SERVICE BULLETIN

SB-012624-A

"I hereby certify the **INSPECTION PORTION ONLY** has been completed in accordance with Service Bulletin (SB-012624-A, NLG Limit Switch Over-Engagement) and all referenced documents. **REPAIR has been deferred to next condition inspection, at which point the repair is mandatory.** Potentially unclear procedures have been clarified with ICON Aircraft (ref. FAA Exemption 10829C)".

Figure 5. Bellcrank Measurement

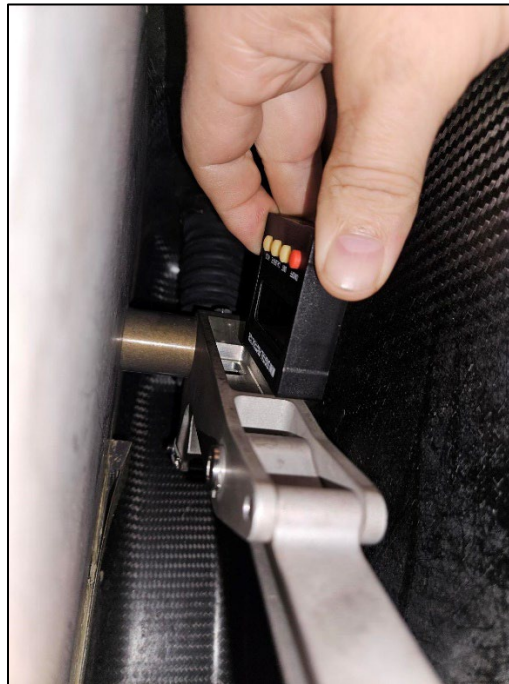
- b. Remove hardware retaining LH headlight to receptacle. Retain hardware for reinstallation.
 6. With the weight off the nose landing gear, gently rotate the NLG bellcrank forward with moderate hand pressure. Record the angle with a digital protractor (see **Figure 5**).

7. With the weight off the nose landing gear, gently rotate the NLG bellcrank backward with moderate hand pressure. Record the angle with a digital protractor, taking care to take the measurement in the same location as before (see **Figure 5**).

8. If the difference between the fwd and aft bellcrank measurements is greater than 1.5°, stop and replace the NLG actuator, including mounting eye bushings and bolts (reference Maintenance Manual sections 100425 and 100359) and repeat the steps above. If less than 1.5°, continue to step 9.

Figure 6. Switch Gap Measurement

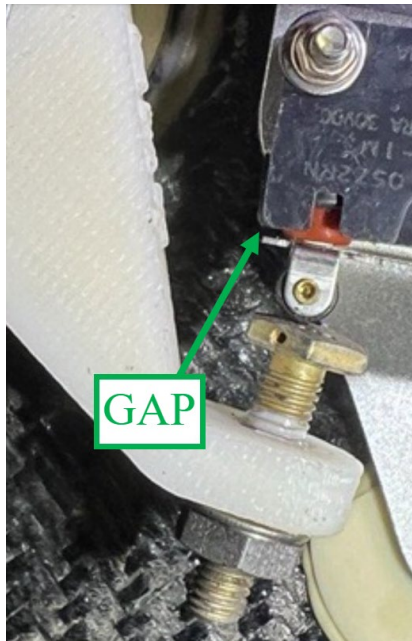
12. Using pin gauges or feeler gauges, reach through the LH headlight opening to inspect the gap between the “extend” or “BOT” switch arm and the switch body just forward of the switch plunger (see **Figure 6**).
 - a. If this gap is zero (the switch arm is touching the switch body), inspect the switch body and the limit switch adjuster bolt bracket for cracks. If damage is found, contact ICON for further instructions.

- b. If the gap measurement is greater than .010 inch, **PASS. Continue to REPAIR or REASSEMBLY.**
 - i. If PASS, the repair can be deferred until the next condition inspection.
- c. If the measurement is less than .010 inch, **FAIL. Continue to REPAIR immediately.**

Figure 7. Bracket Modifications for 10-32 Studs

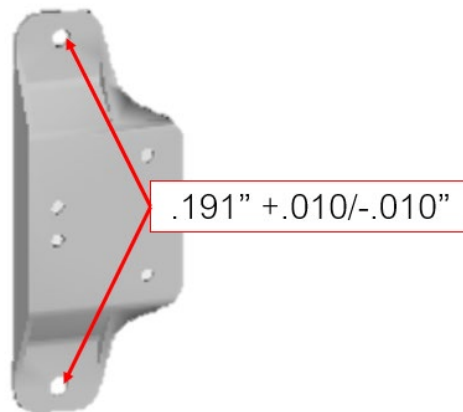
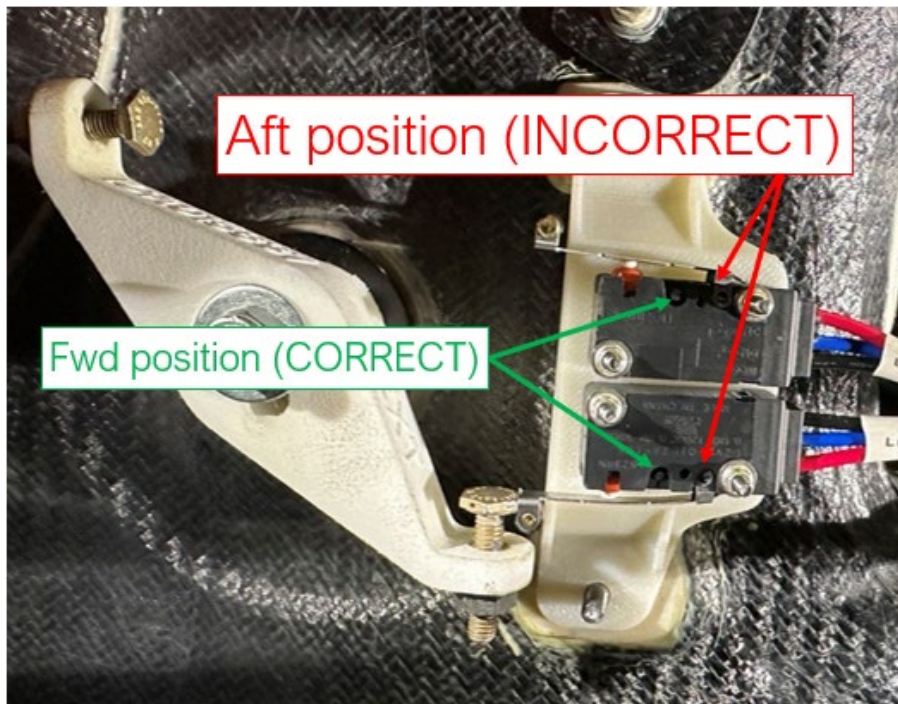
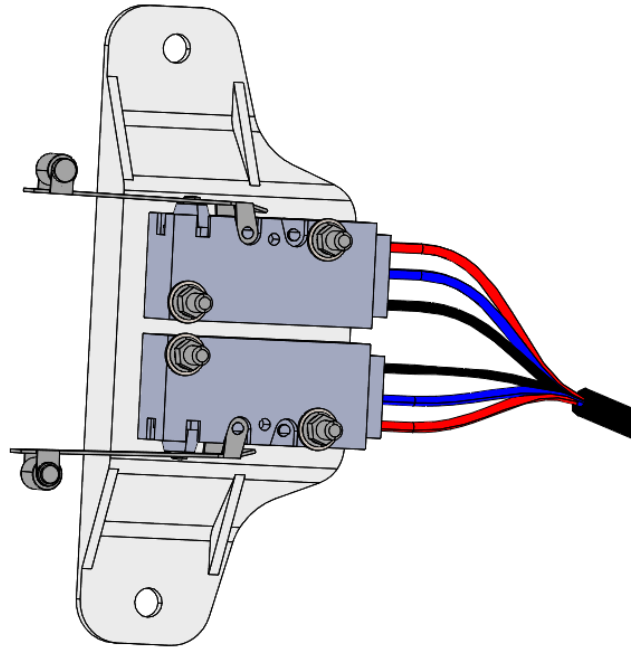
2. Remove the NLG limit switch mounting bracket from the studs. Identify whether 8-32 or 10-32 studs were installed.
3. For aircraft with 10-32 studs, modify the new Limit Switch Bracket (ICA016042) by increasing the size of the 2x holes indicated in **Figure 7** to $.191" +.010/-0.000"$.

Figure 9. Adjuster Bolt Hardware Stackup

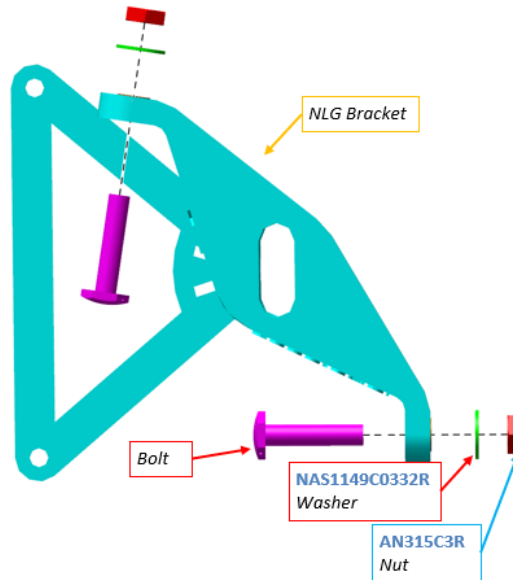
6. Re-install switches on new mounting bracket (ICA016042). Torque screws to 4 in-lb.
7. Remove the (2) adjuster bolts from the limit switch bracket assembly; retain jam nuts and washers. See **Figure 9**.

9. Install thumbscrews in the same manner as the bolts from **Figure 9**.
 - a. Adjust screw on limit switch retrofit bracket so bottom (“BOT”) extended limit switch is activated. Adjust screw gap on limit switch retrofit bracket so that top (“TOP”) side has the same gap as the bottom.

- b. Tighten jam nuts to a sharp rise in torque, taking care not to rotate the thumbscrews. A small rotation of the thumbscrew can significantly affect rig.

Figure 10. Installed limit switch subassembly; (1.0 config: Orient 90° clockwise)

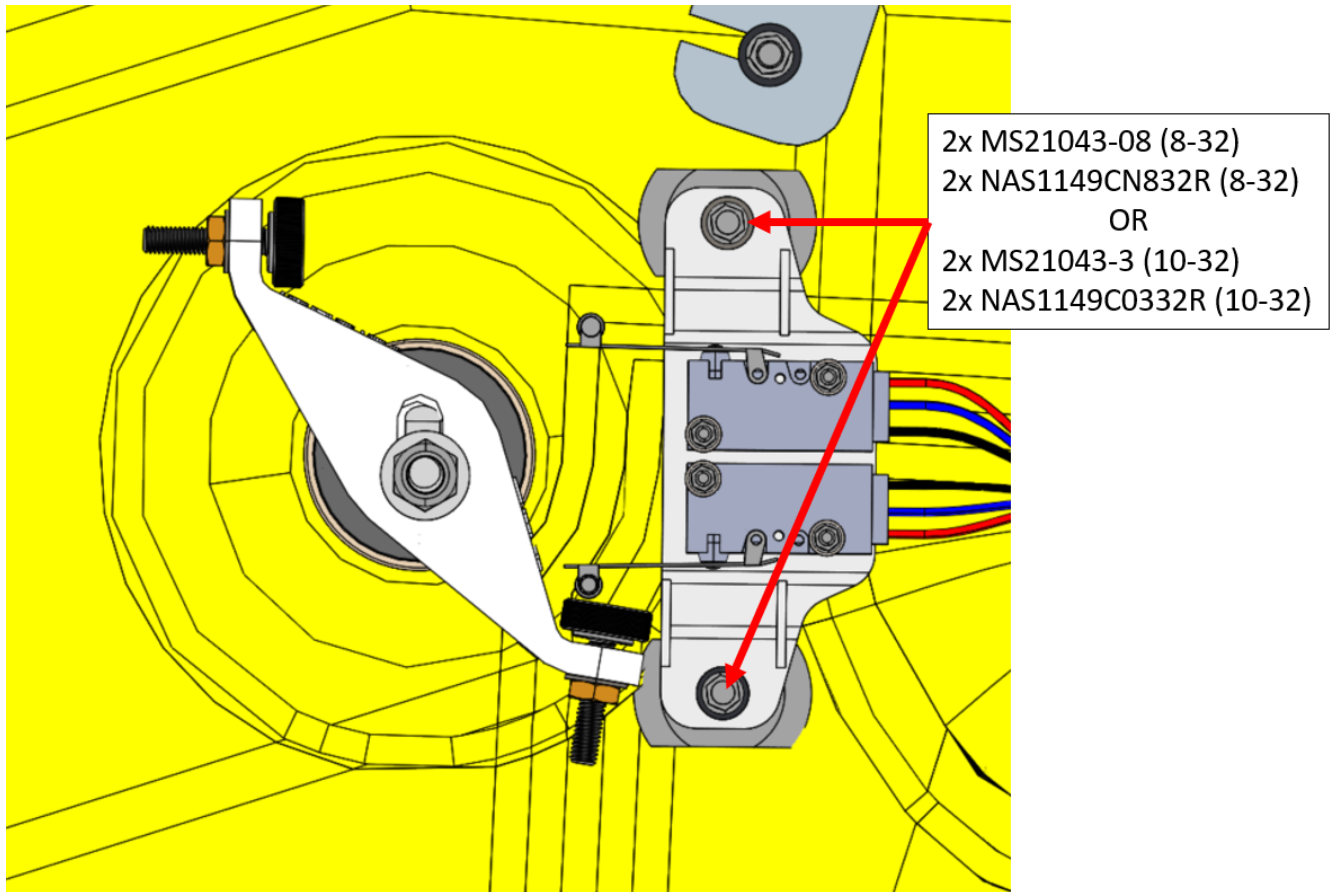
10. Using isopropyl alcohol, clean surfaces where lubricant will be applied. Apply ICA012078 Tef-Gel to the threads of the studs. Install limit switch assembly onto studs as shown in **Figure 10** below with:

- a. If 8-32 studs were used: 2x NAS1149CN832R washers and 2x MS21043-08 nuts torqued to 14 in-lb.
 - b. If 10-32 studs were used: 2x NAS1149C0332R washers and 2x MS21043-3 nuts torqued to 20 in-lb.
